CITY OF CODY  
PLANNING, ZONING AND ADJUSTMENT BOARD  
TUESDAY, MAY 22, 2018  
CITY HALL COUNCIL CHAMBERS @ 12:00 NOON

**CITY OF CODY  
PLANNING, ZONING AND ADJUSTMENT BOARD  
STAFF REPORT**

<b>MEETING DATE:</b>	MAY 22, 2018	<b>TYPE OF ACTION NEEDED</b>	
<b>AGENDA ITEM:</b>		P&Z BOARD APPROVAL:	
<b>SUBJECT:</b>	CONCEPTUAL PLAT—A 5-LOT MINOR SUBDIVISION FOR THE WAY WEST LLC. SUB 2018-02	RECOMMENDATION TO COUNCIL:	
<b>PREPARED BY:</b>	TODD STOWELL, CITY PLANNER	DISCUSSION ONLY:	X

Existing:

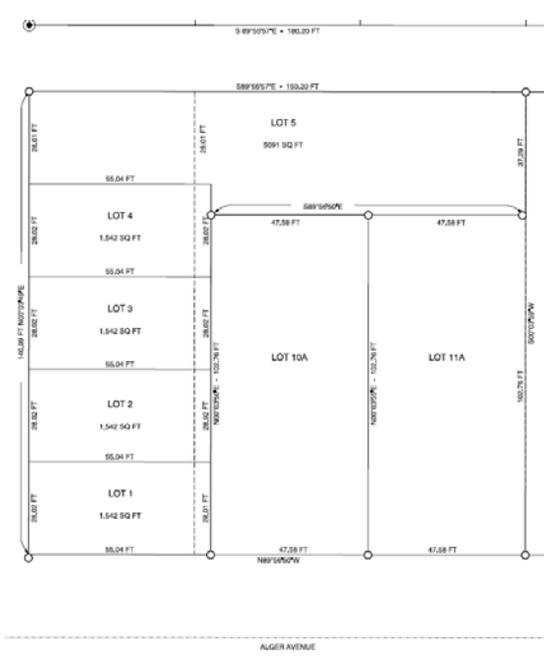
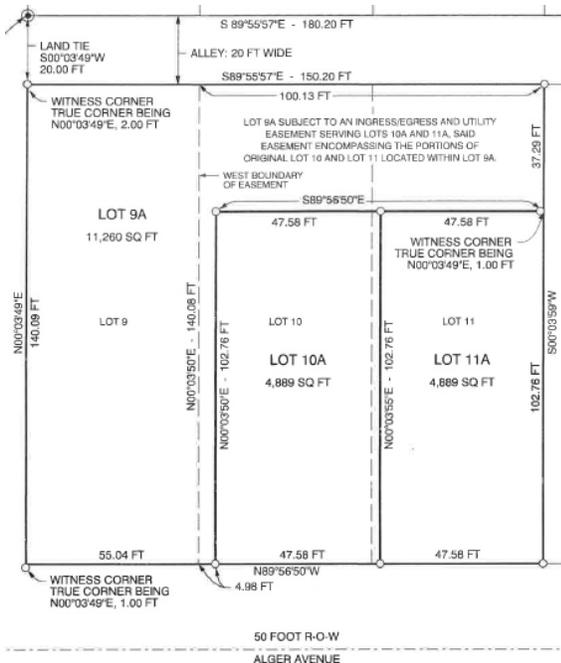
The property is located northeast of the 12<sup>th</sup> Street and Alger Avenue intersection. It was recently involved in a boundary line adjustment that reconfigured three lots into the configuration shown below. The proposal is to divide the west lot (9A) into five buildable lots, and perhaps one common area tract (the east portion of Lot 5 that is encumbered by the access and utility easement.)

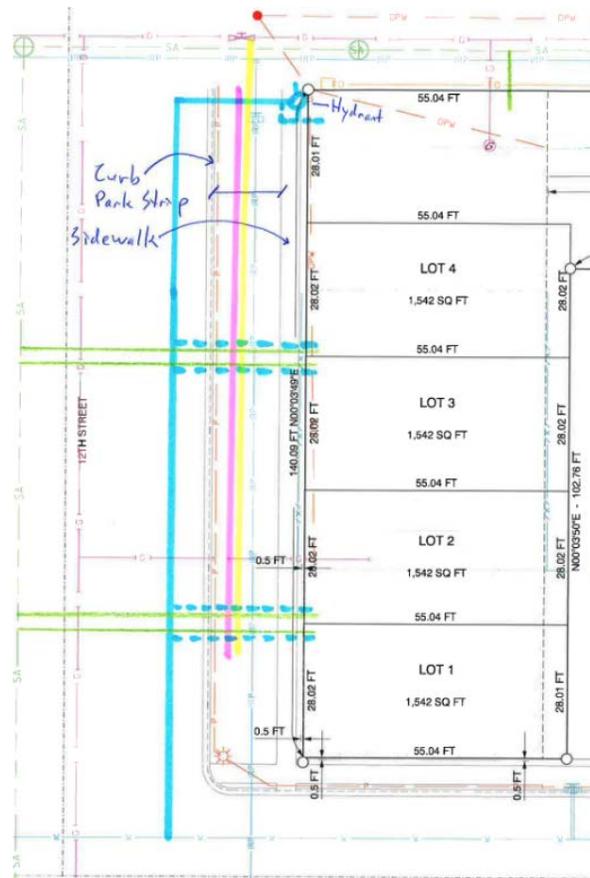
*Utilities:* Each lot is required to have its own utility services, tied back to the main lines. The applicant has not yet provided a utility plan for the lots. Staff put together the following layout to the right as a possible option. (Green=sewer, Blue=water, Pink=power, Yellow=gas.) Additional engineering is needed and will need to be submitted with the preliminary plat application.

**CONCEPTUAL PLAN**

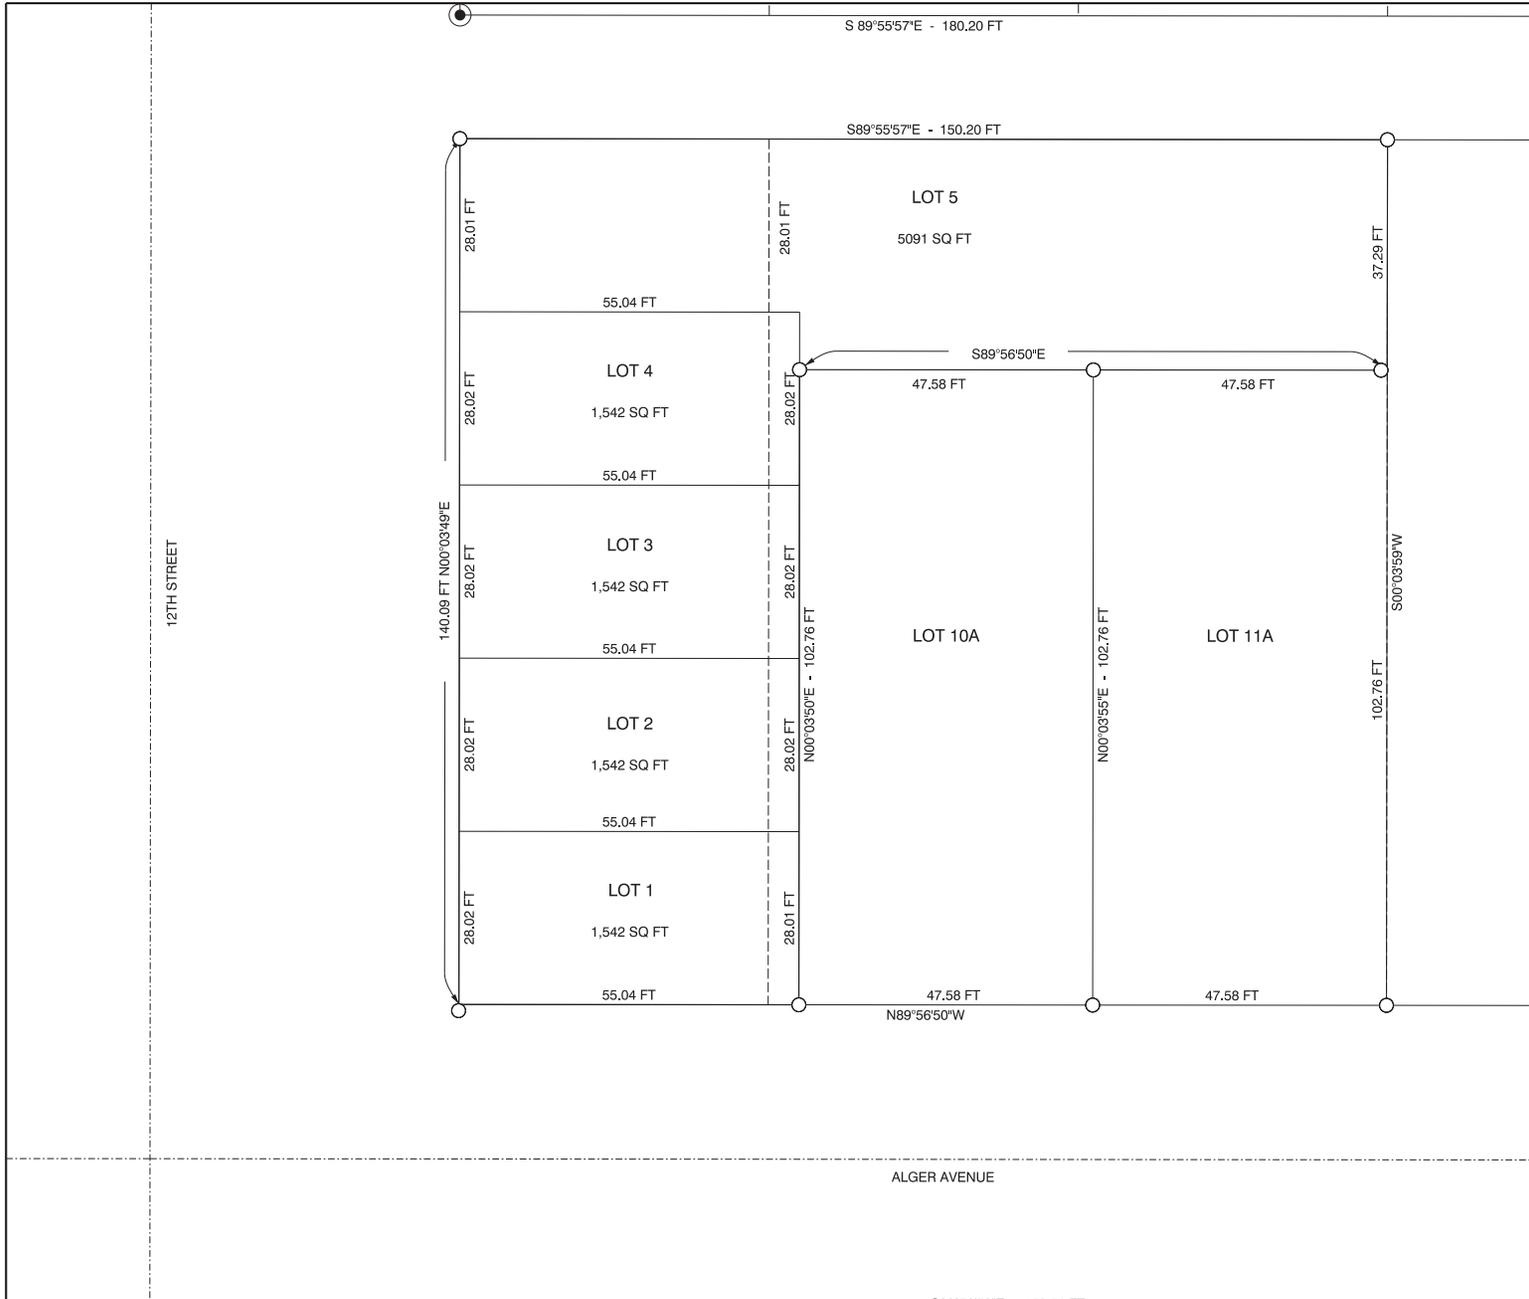
flag lot). While the zoning ordinance was amended last year to clearly allow less street frontage in the residential districts, the subdivision ordinance has not yet been amended. A variance to the 50-foot frontage standard is requested to allow the 28-foot lot widths shown. For comparison, it is noted that all of main street and much of downtown is composed of lots with only 25 feet of street frontage. Also, the R-4 multi-family zoning district allows a minimum lot width of 20 feet for an interior lot and 30 feet for a corner lot, when the access, sight distance, and parking situations are acceptable, as appears to be the case here. However, anything less than 50 feet technically needs a variance.

Staff supports the lot width requested. It is noted that the D-2 zone would allow even more compact dwellings than proposed if the property was not being divided, or if the development was done through the condominium process. Also, the property is in a downtown commercial location, where density and redevelopment is encouraged.

*Alleys:*  
The subdivision would not have a "rear" alley. A variance to the standard would be needed.

While parking is usually not a topic discussed at the subdivision stage, this would be the exception. If each lot is used for a townhouse, the standard requirement is for two, off-street parking spaces on each lot. (There is no "grandfather" discussion here because those rights will be lost when the existing buildings are demolished.) A formal parking agreement would allow use of a common parking area (east portion of Lot 5). However, adjacent Lots 10A and 11A have a right of access across that area and unless the parking agreement includes them and clarifies parking rights, I don't think the subdivider can claim all eight spaces shown on the site plan. Realistically, the difference between the number of spaces in the common parking area and the number needed could typically be accommodated by the eleven on-street spaces along 12<sup>th</sup> Street frontage. However, to "count" any of those spaces towards meeting the parking needs for the development would require a special exemption. I bring it up now to get feedback from the Board if they would be open to such a special exemption. The spaces would not be "reserved" for the lots but would be recognized as being available to help meet parking demand in the area.
